City of Garden City
Development Services Department
6015 Glenwood Street
Garden City, ID 83714

RE: Design Review Report and Decision Draft Report Response:
File Number DSRFY2025-0008

ANTIOCH APARTMENTS

TRASH ENCLOSURES -- BASIS OF DESIGN

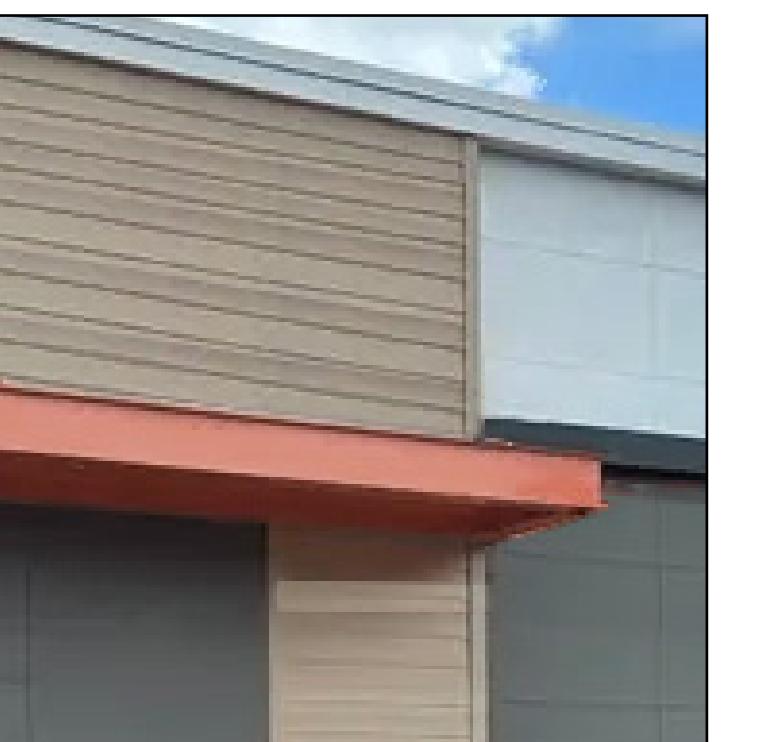
Comment:

Response: *The primary terminal view looking south after one enters the site is building 2, while several other secondary terminal views include views of the trash enclosures. Trash enclosure locations are driven by functionality and will be built in an esthetically pleasing way. See basis of design images on sheet A-3*

Sheet A-19

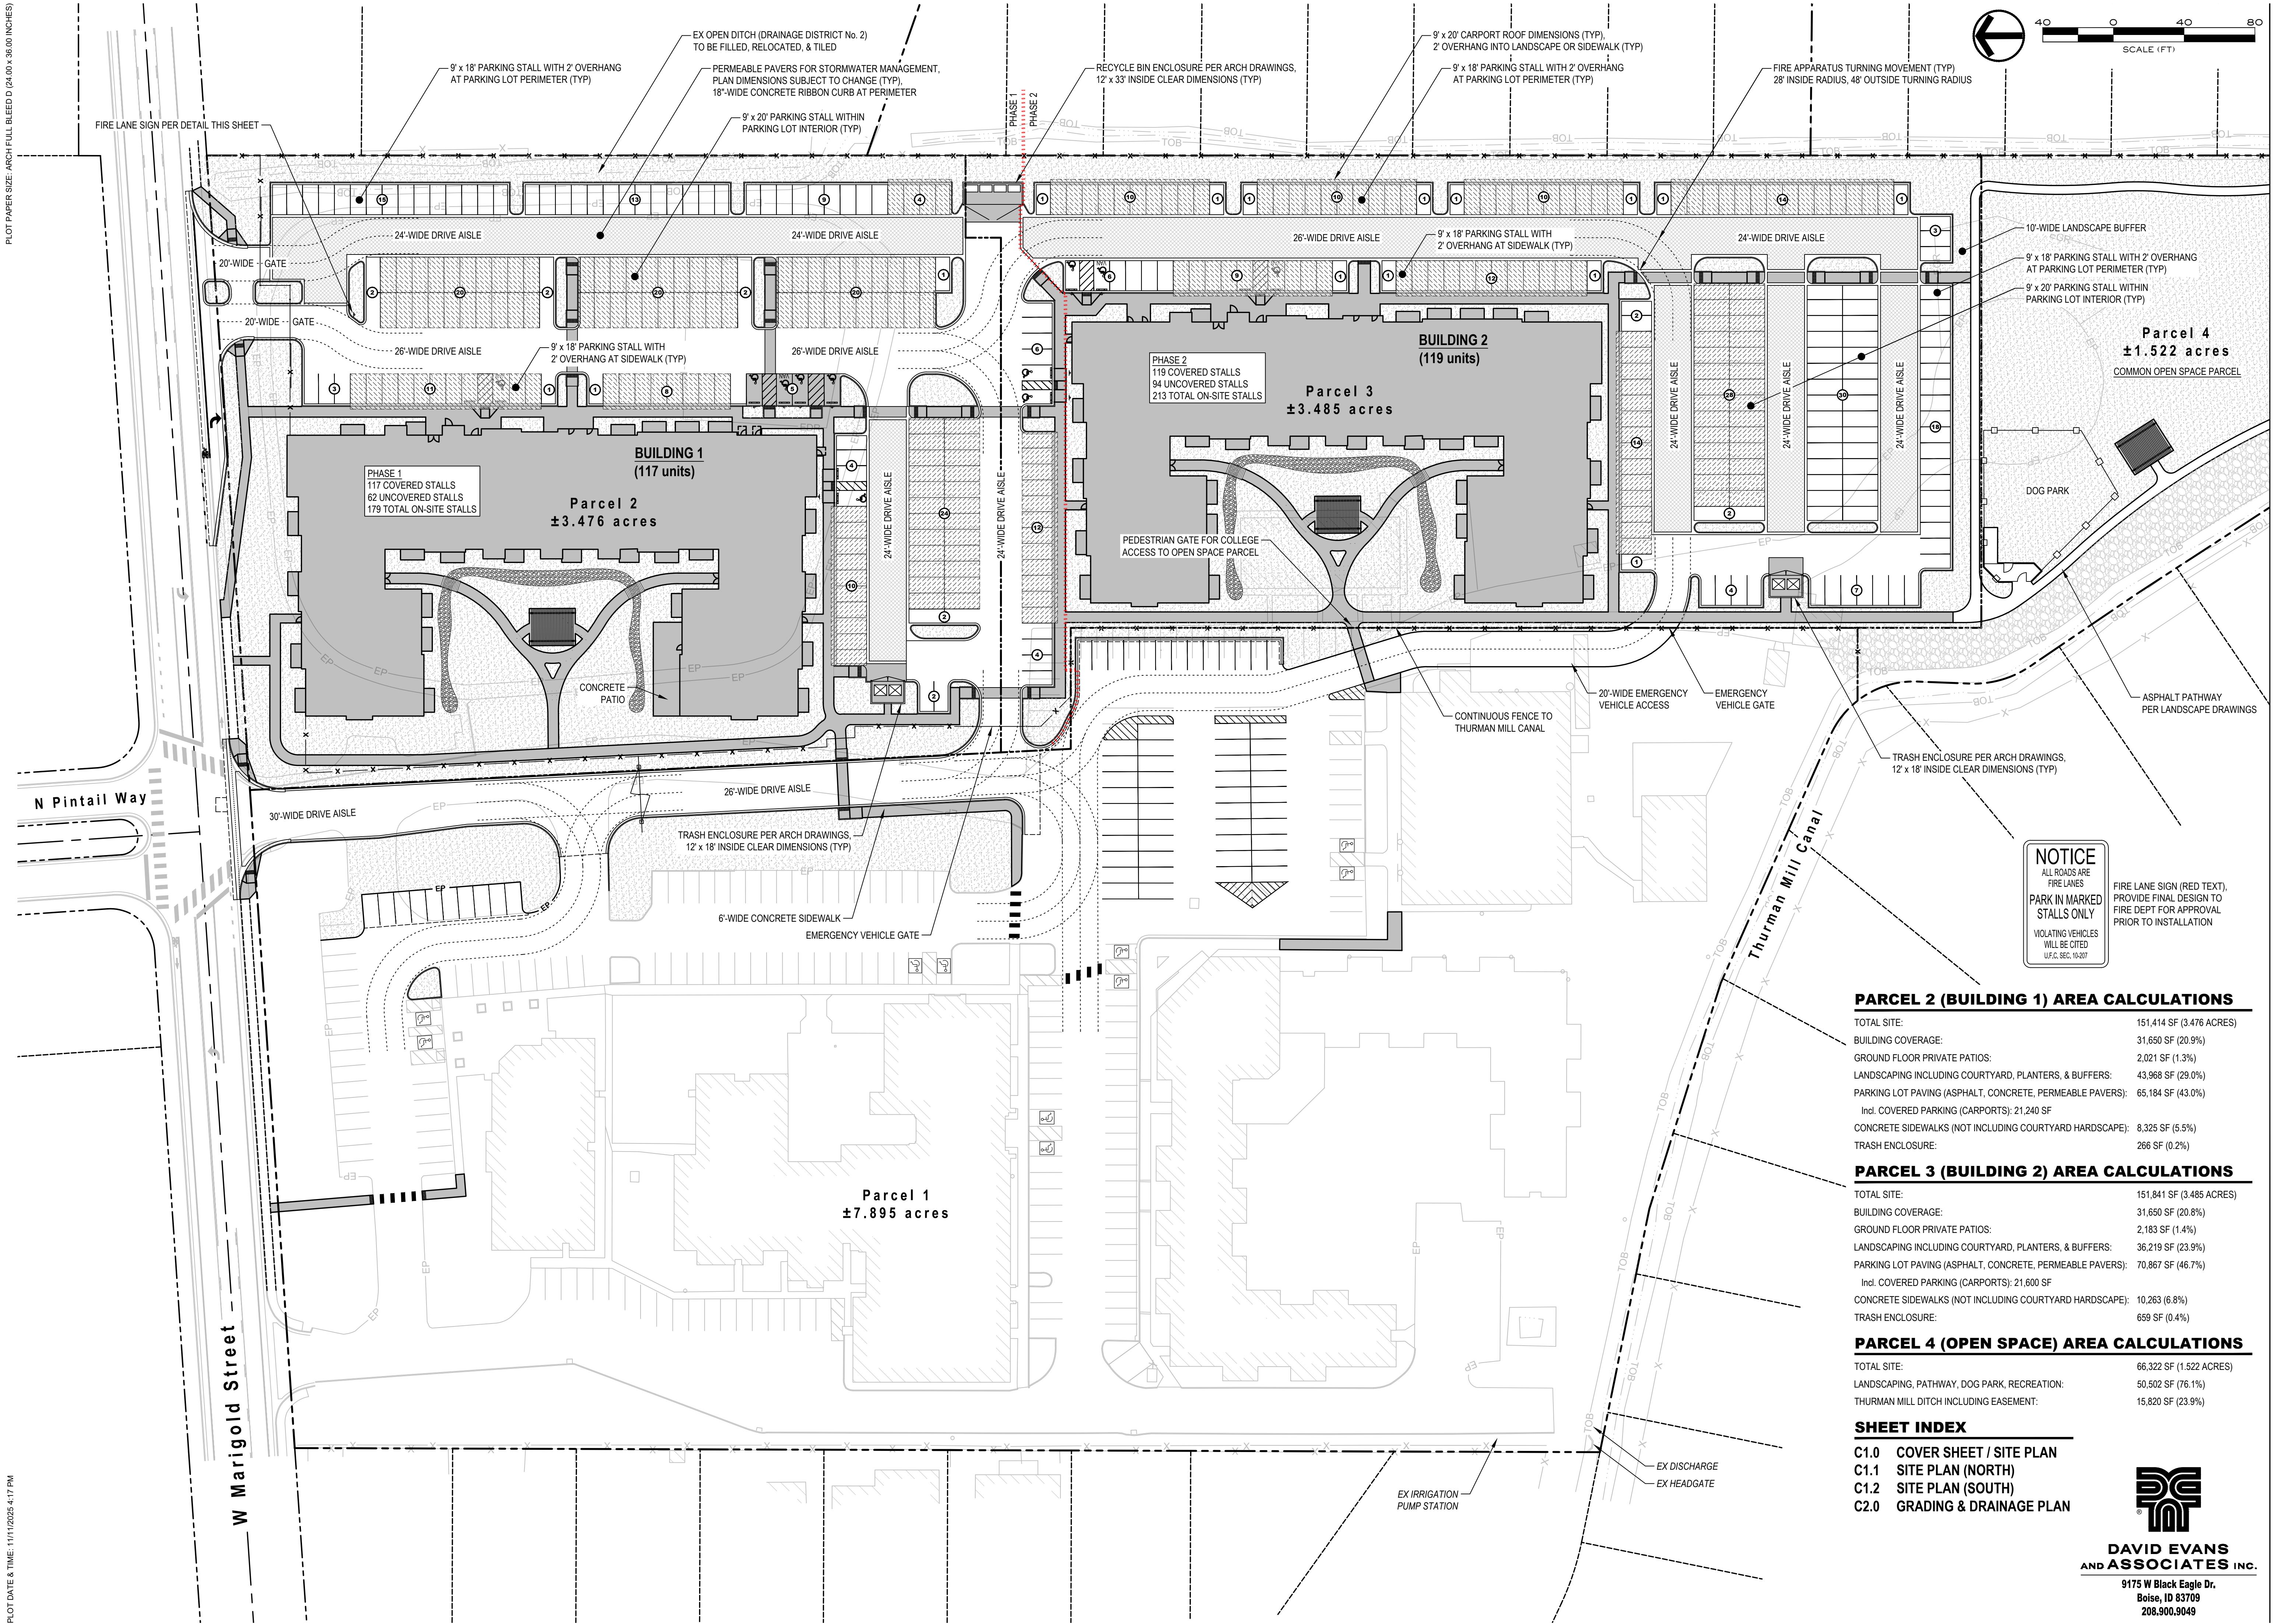
Staff does not see a detail indicating the amount of bike parking to be provided. Clarification needed.

Response: *Vehicle and bicycle parking data is shown on architectural sheet A-19.*

Overall Landscape Plan
Sheet Number L1.00

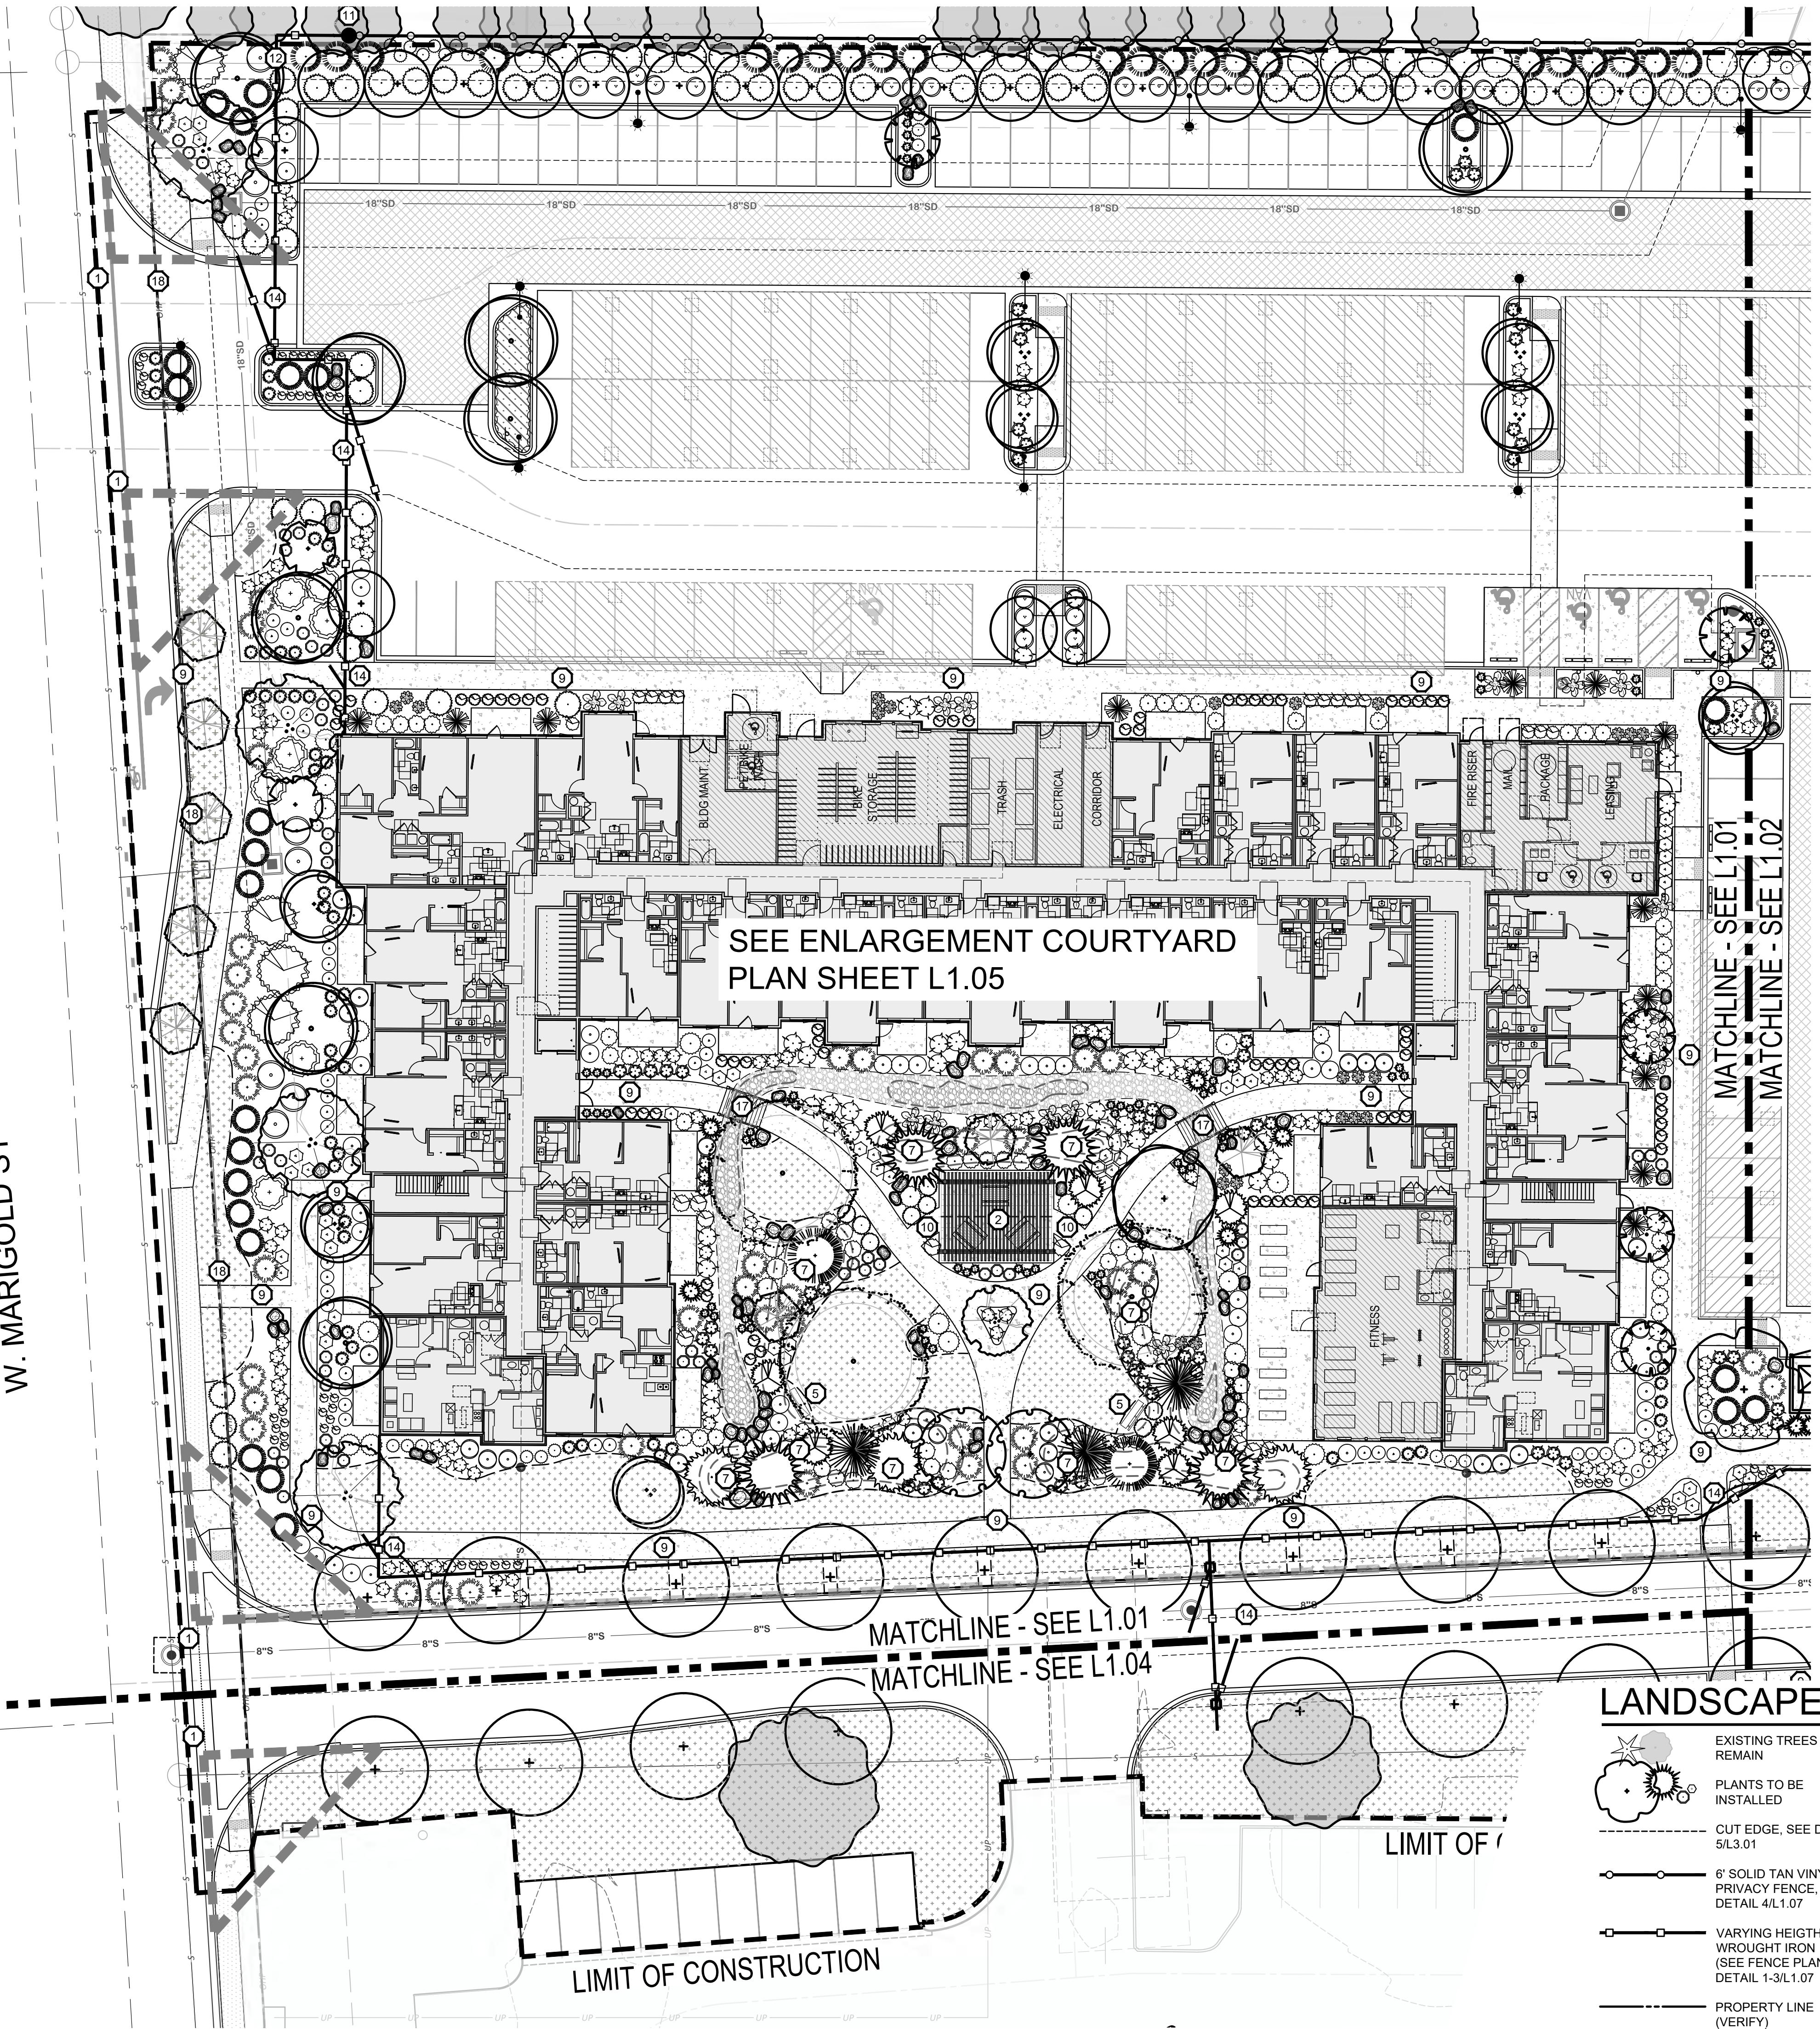
A minimum of one class III or class II tree shall be planted in the frontage and every adjacent streetside. An additional class I tree shall be planted in the corresponding setback for every increment of fifty feet (50') of linear feet of frontage.

Note: Staff recommends requiring Class II street trees (or larger where planting strip width allows) along public frontages to maximize cooling, public health, habitat, stormwater, and long-term canopy outcomes; Class I trees should only be permitted where overhead utilities or substandard planter widths preclude larger forms. This is consistent with regional practices and local streetscape precedents of new developments in Garden City. Conditions have been drafted to require Class II or III trees in lieu of the Class I trees.

Response: *Revisions to the landscaping plan have been made to include Class II street trees, Class I trees have been maintained where overhead lines are present. Trees within courtyards and south common area have been revised to class III trees. See sheet L1.00 for updated gross site landscape areas without buffers.*
